# Service Update

## N212340733 Cargo Carrying Capacity Reduced Label

Release Date: June 2021

<b>Condition</b>	Certain 2021 model year GMC Canyon vehicles may have their vehicle loading weight specification incorrectly noted on the Tire and Loading Information label.
<b>Correction</b>	Dealers will add the Cargo Carrying Capacity Reduced label.

5868279

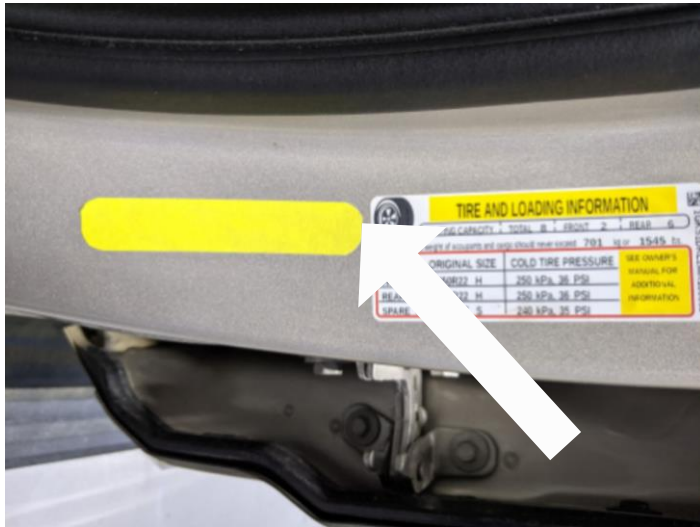
Note: The graphic below shows both the US and Canadian versions of the Cargo Carrying Capacity Label.

2. Select the appropriate language Cargo Carrying Capacity Reduced Label for your sales market.
